In re: Denbury Green Pipeline-North Dakota, LLC
12-Inch Cedar Hills Pipeline Project
Slope and Bowman Counties
Case No. PU-19-294
Our File No. 025331-000058

Certification and documentation for route adjustment under section N.D.C.C.49-22.1-15(3)&(1)

Subject: CHSU Lateral CO2 Pipeline Project
Bowman County, North Dakota
Route Adjustments and Proposed Additions to the Designated Corridor

Proposed Change to Designated Route No.1

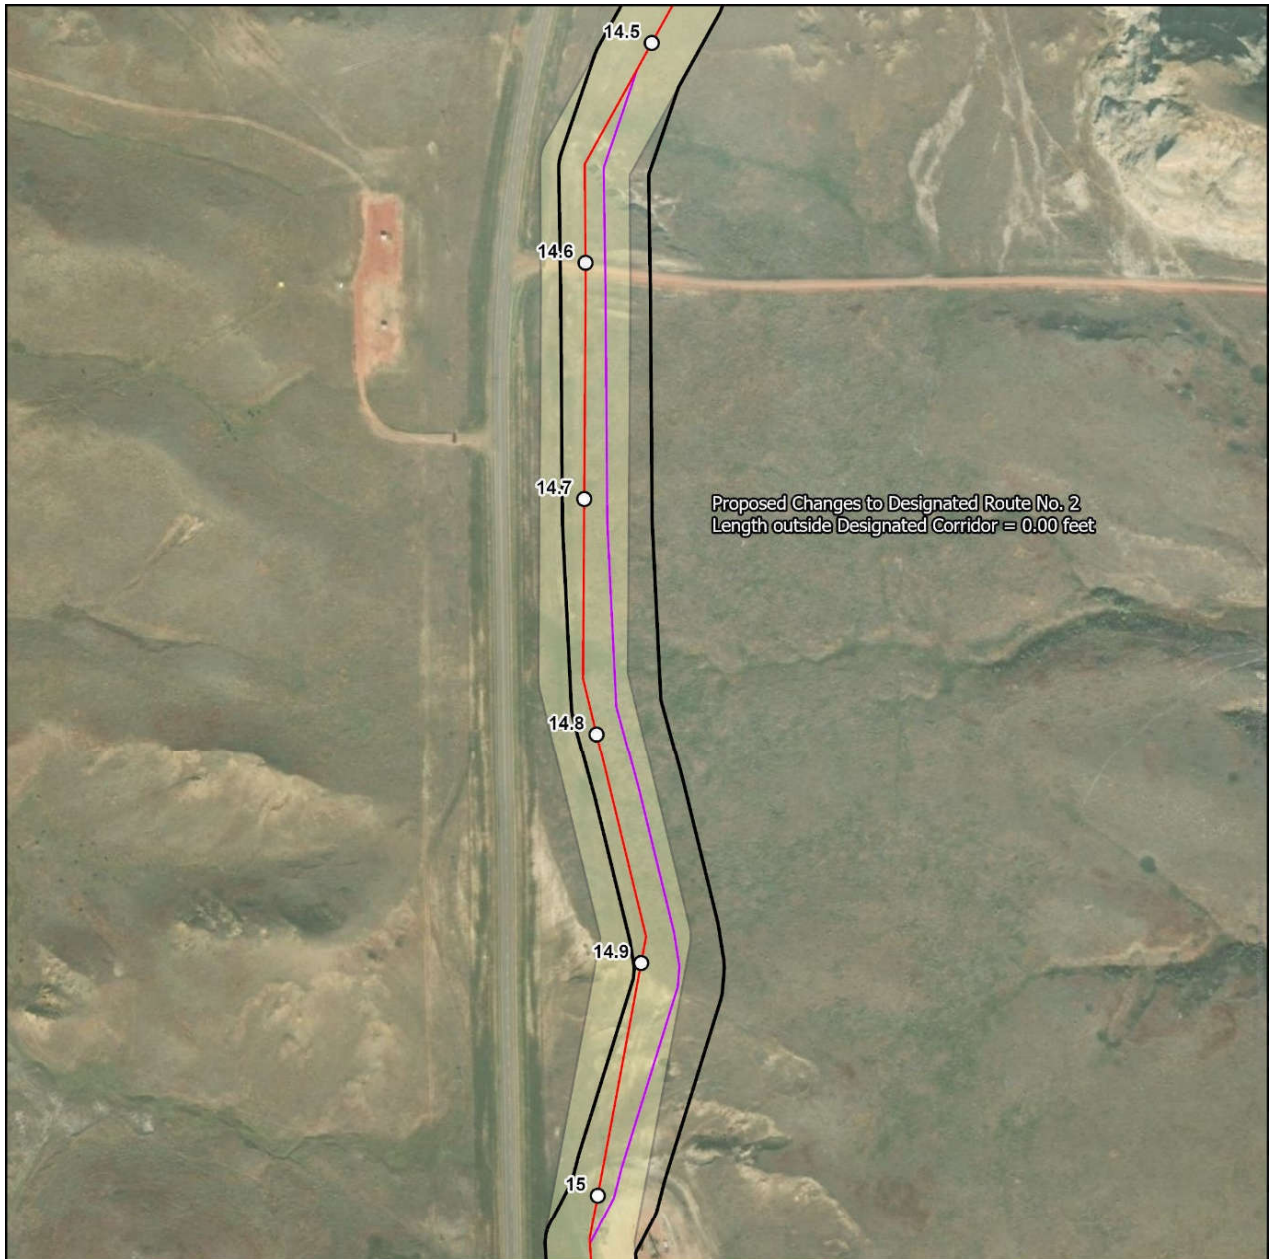
It is SWCA’s understanding that at the start of Project construction, Denbury identified two new utilities and one area with constructability issues that will require two route adjustments: Route Adjustment No. 1 is necessary to avoid the two underground utilities and will result in relocating the Designated Route outside of the Designated Corridor. Route Adjustment No. 2 will require shifting the Designated Route to the east of its designated location but still within the Designated Corridor. For both route adjustments, the location of the 200-foot wide Designated Corridor will change to keep it centered on the new proposed pipeline route. In addition to the proposed route adjustments, Denbury identified 5 locations where the workspace area for pipeline construction will have to extend beyond the Designated Corridor and thus, these areas should be considered as proposed additions to the Designated Corridor. Information on the route adjustments and proposed additions to the Designated Corridor are summarized in the following table and maps of the route adjustments and proposed corridor additions are included in a separate attachment.

Figure 2. Route Adjustment No. 1 location map.

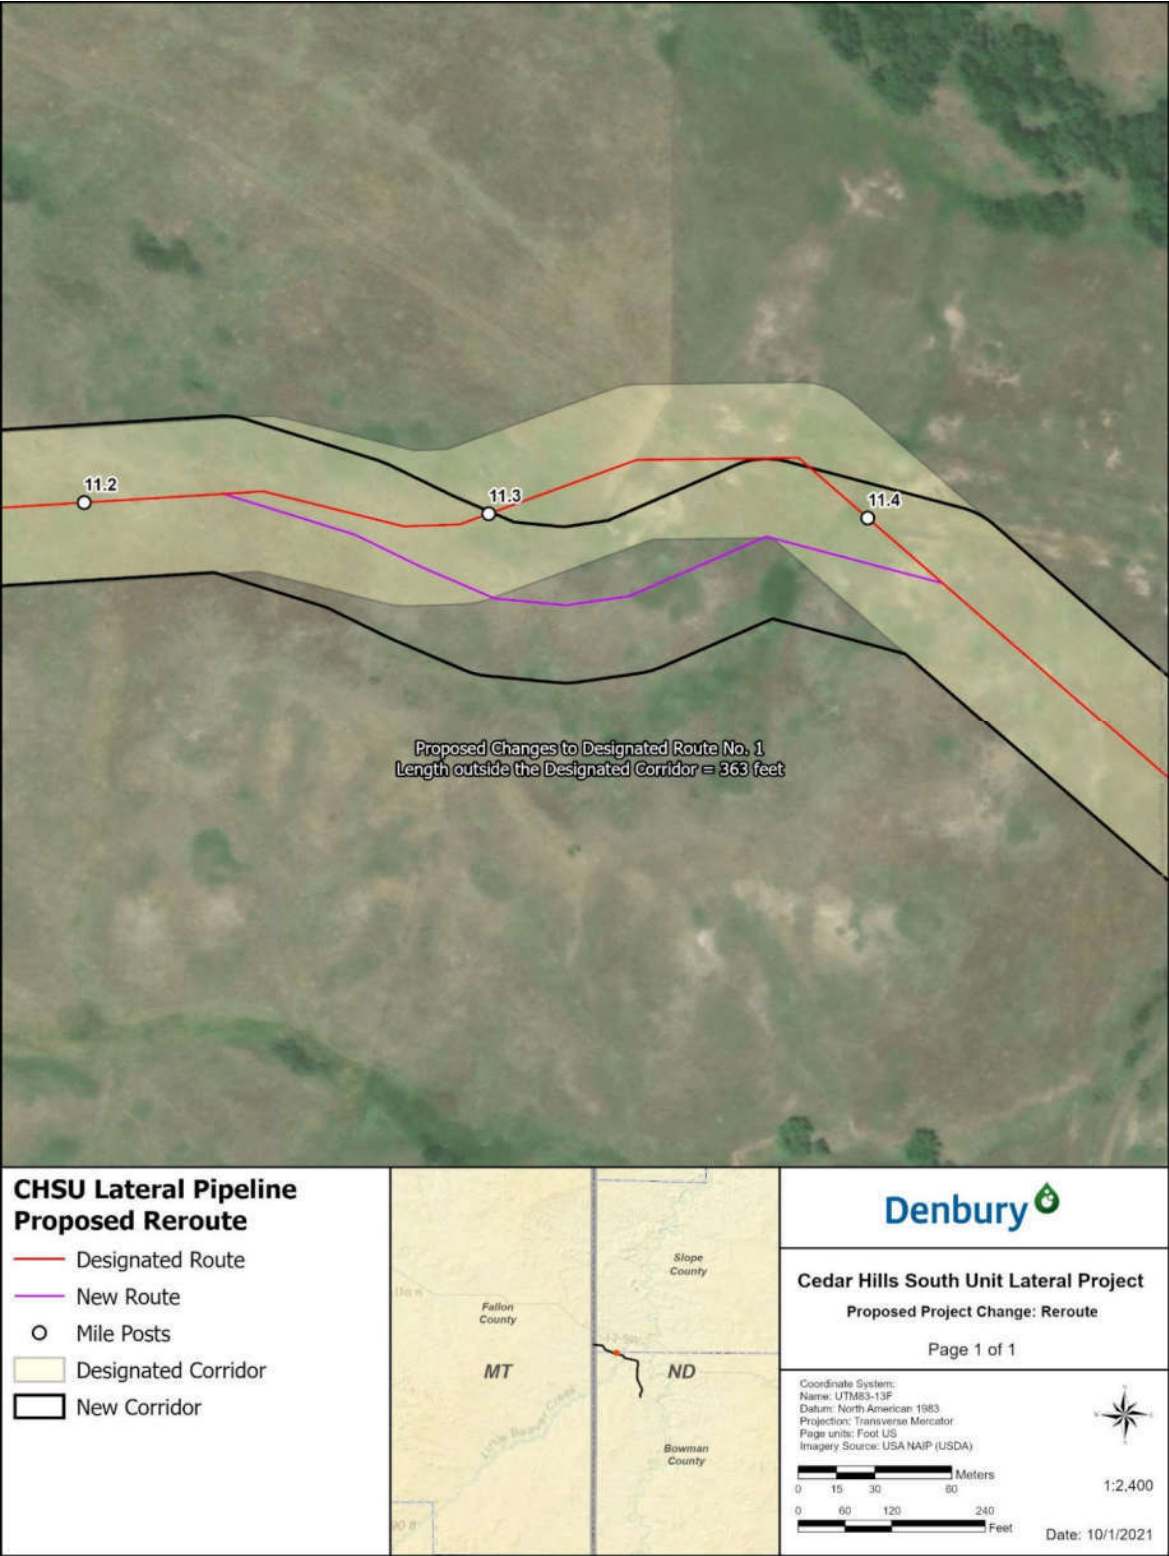
- Route Adjustment No. 1 – the route adjustment is completely within the one-mile-wide project study area for the desktop analysis and approximately 363 feet of the reroute lies outside of the Designated Corridor (Figure 2). No transmission facility corridor and route exclusion and avoidance areas were identified during the desktop analysis and field surveys for the proposed pipeline route and aerial photographic interpretation of the route adjustment indicates that a pedestrian survey of the reroute is not warranted.
- Route Adjustment No. 2 – required for constructibility concerns; the route adjustment is completely within the one-mile-wide project study area for the desktop analysis and, while the rerouted pipeline itself lies within the Designated Corridor, approximately 2,689 feet of the associated temporary construction easement lies outside of the Designated

Corridor which will have to be relocate as shown in Figure 4. No transmission facility corridor and route exclusion and avoidance areas were identified during the desktop analysis and field surveys for the proposed pipeline route and aerial photographic interpretation of the route adjustment indicates that a pedestrian survey of the reroute is not warranted.

Figure 3. Route Adjustment No. 2 location map.

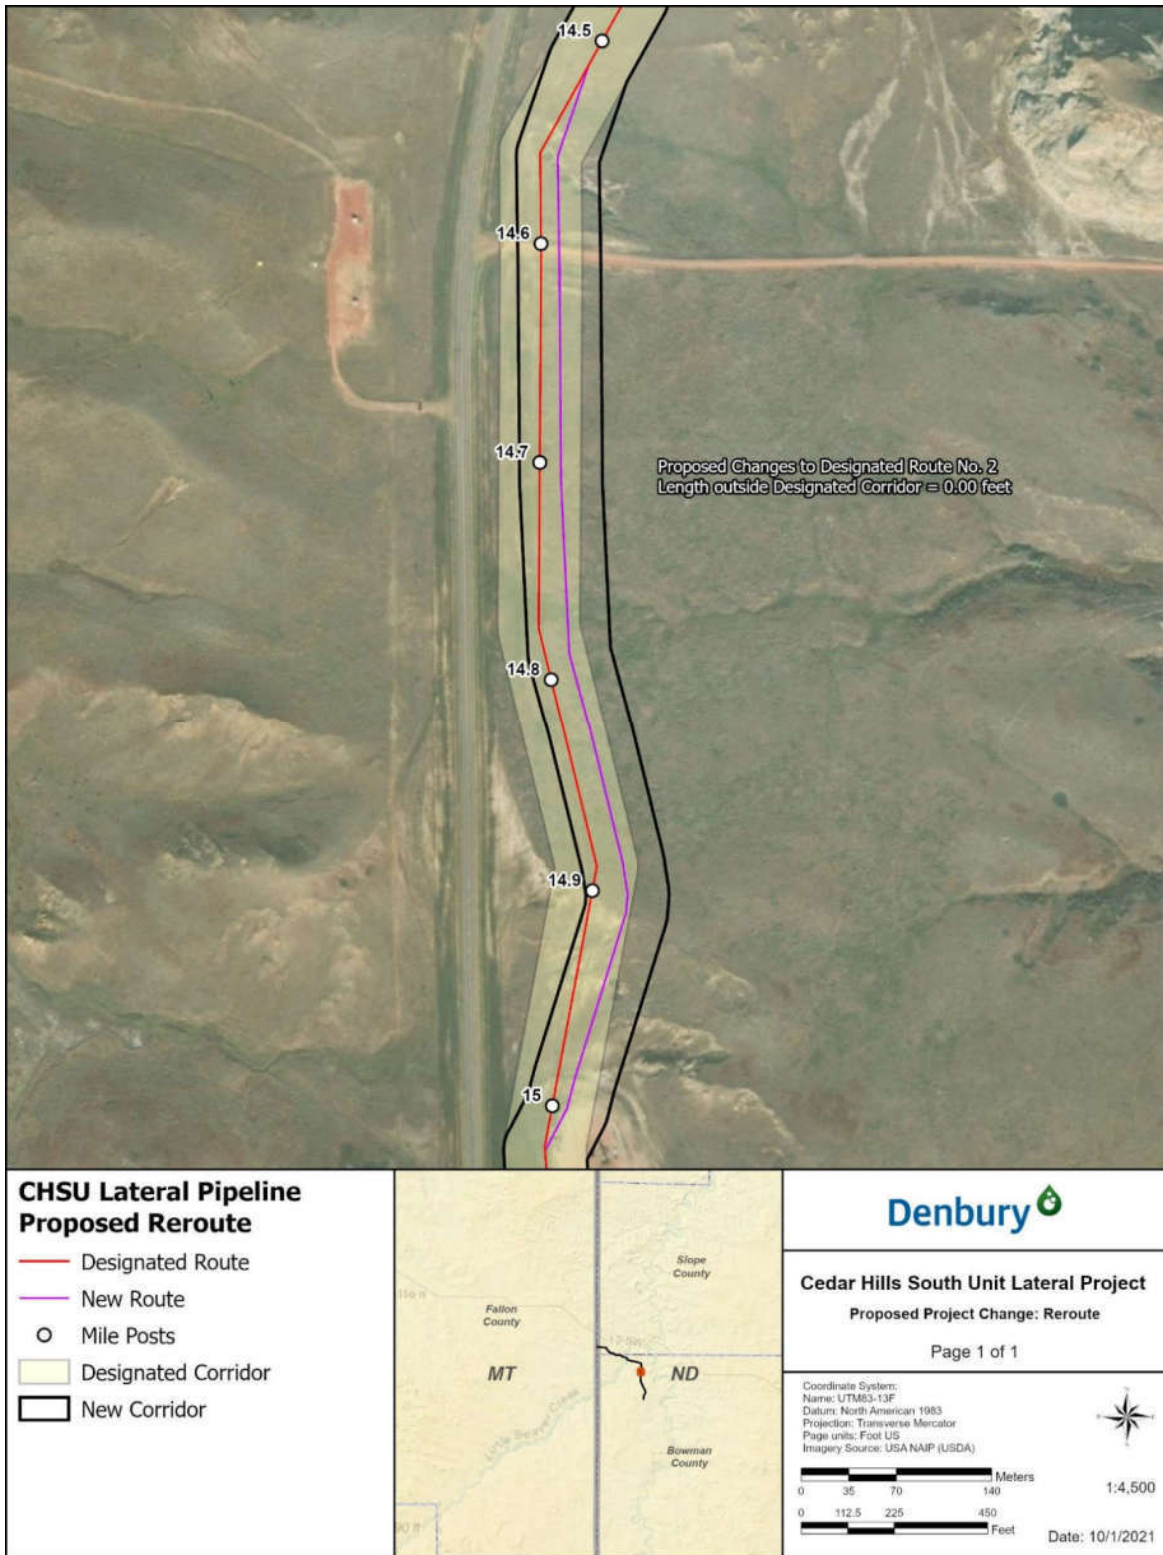
Since the start of Project construction, Denbury identified two locations where the pipeline route will have to be moved to avoid two previously unknown underground utilities (Route Adjustment No. 1) and for constructability concerns (Route Adjustment No. 2), plus five additional temporary workspace areas (i.e., proposed additions to the Designated Corridor) in Bowman County that are necessary to facilitate pipeline construction. As summarized in Table 1 and illustrated in the attached figures, the pipeline reroute for Route Adjustment No. 1 (Figure 2) is partly outside the Designated Corridor, while the pipeline location for Route Adjustment No. 2 (Figure 3) is within the Designated Corridor, but the associated construction easement for this reroute is partly outside the Designated Corridor. Proposed additions to the Designated Corridor No. 1, No. 2, No. 3, and No. 4 (Figure 4), and proposed addition to the Designated Corridor No. 5 (Figure 5) are portions of temporary work areas required for pipeline construction that extend outside the Designated Corridor. Because the pipeline reroutes, construction right-of-way (ROW), and proposed corridor additions are partly outside of the Designated Corridor, notification of these required changes to the Designated Corridor and Designated Route must be filed with the NDPSC per NDCC §49-22.1-15.3 for Route Adjustment No.1, NDCC §49-22.1-15.1 for Route Adjustment No. 2, and NDCC §49-22.1-06.4 for the proposed additions to the Designated Corridor.

Figure 4. Proposed Corridor Additions 1, 2, 3, and 4 location map.

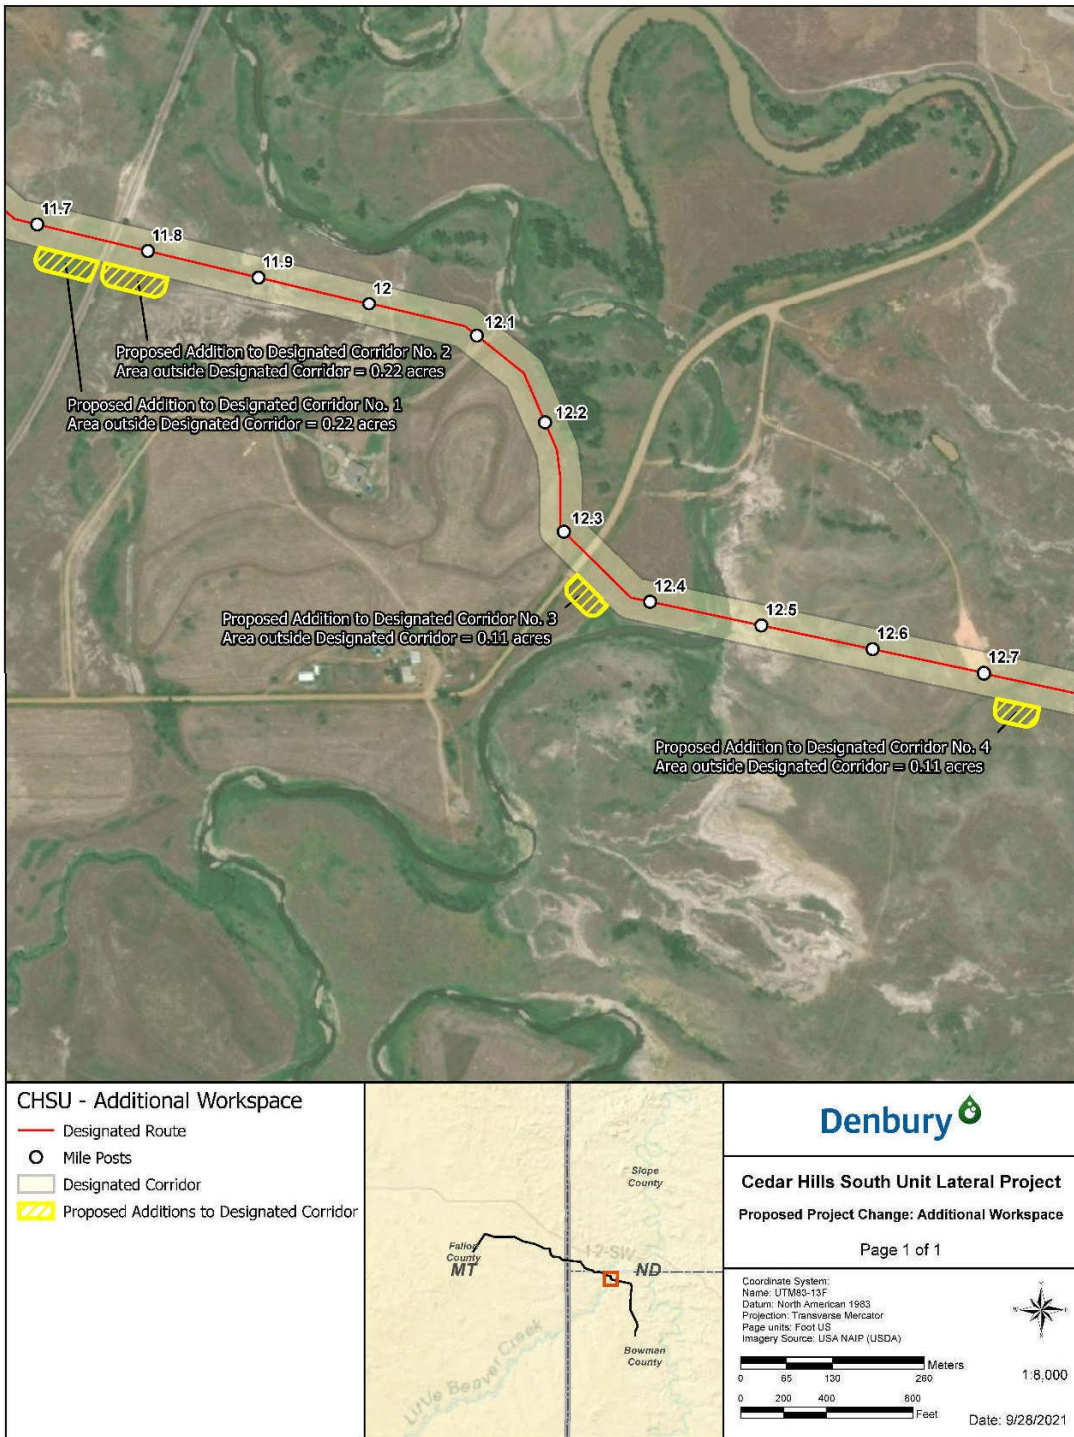
- Proposed Corridor Addition No. 1 – this proposed addition is for expansion of a temporary workspace area from approximately 100 x 100 feet to 100 x 200 feet, with an area that measures approximately 50 x 200 feet (0.22-acre) outside of the Designated Corridor (Figure 3). No transmission facility corridor and route exclusion and avoidance areas were identified during the desktop analysis and field surveys for the proposed pipeline route and aerial photographic interpretation of this proposed corridor addition indicates that a pedestrian survey of the area is not warranted.

- Proposed Corridor Addition No. 2 – this proposed addition is for expansion of a temporary workspace area from approximately 100 x 100 feet to 100 x 200 feet, with an area that measures approximately 50 x 200 feet (0.22-acre) outside of the Designated Corridor (Figure 3). No transmission facility corridor and route exclusion and avoidance areas were identified during the desktop analysis and field surveys for the proposed pipeline route and aerial photographic interpretation of this proposed corridor addition indicates that a pedestrian survey of the area is not warranted.

- Proposed Corridor Addition No. 3– this proposed addition is for a temporary workspace area that measures approximately 100 x 100 feet, with an area that measures approximately 50 x 100 feet (0.11-acre) outside of the Designated Corridor (Figure 3). No transmission facility corridor and route exclusion and avoidance areas were identified during the desktop analysis and field surveys for the proposed pipeline route and aerial photographic interpretation of this proposed corridor addition indicates that a pedestrian survey of the area is not warranted.

- Proposed Corridor Addition No. 4– this proposed addition is for a temporary workspace area that measures approximately 100 x 100 feet, with an area that measures approximately 50 x 100 feet (0.11-acre) outside of the Designated Corridor (Figure 3). No transmission facility corridor and route exclusion and avoidance areas were identified during the desktop analysis and field surveys for the proposed pipeline route and aerial photographic interpretation of this proposed corridor addition indicates that a pedestrian survey of the area is not warranted.

Figure 5. Proposed Corridor Addition No. 5 location map.

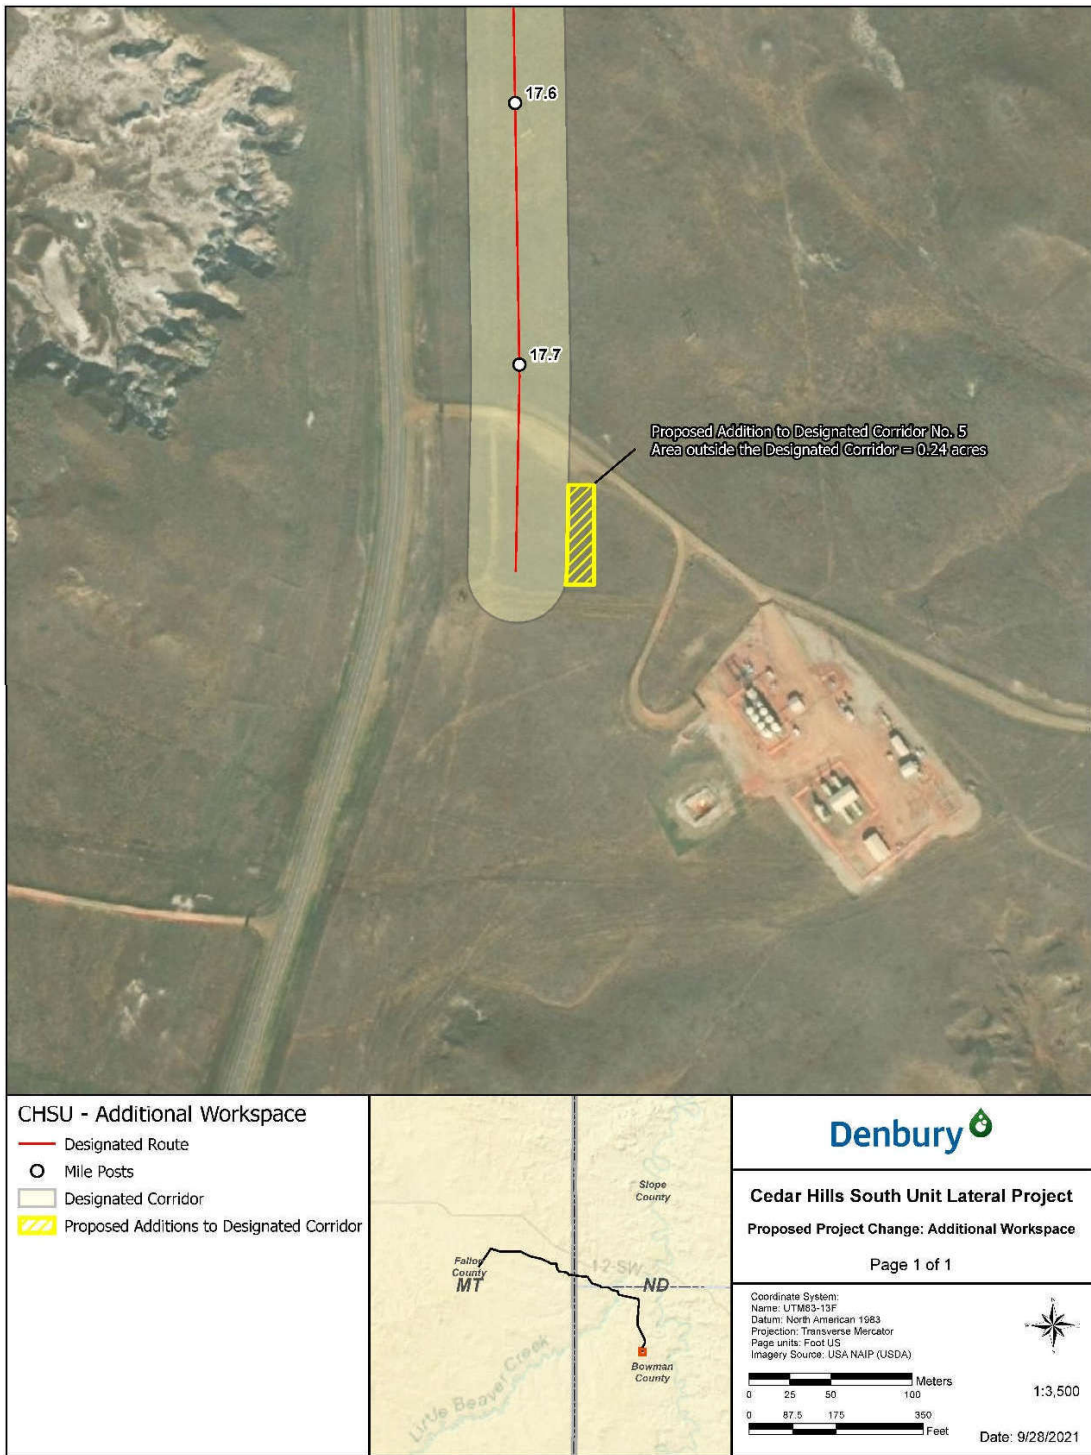
- Proposed Corridor Addition No. 5 – this proposed addition is for a portion of the Miller Station that measures approximately 52 feet by 200 feet (0.24 acre) that was not included in the previous field survey and Designated Corridor (Figure 3). No transmission facility corridor and route exclusion and avoidance areas were identified during the desktop analysis and field surveys for the proposed pipeline route and aerial photographic interpretation of this proposed corridor addition indicates that a pedestrian survey of the area is not warranted.
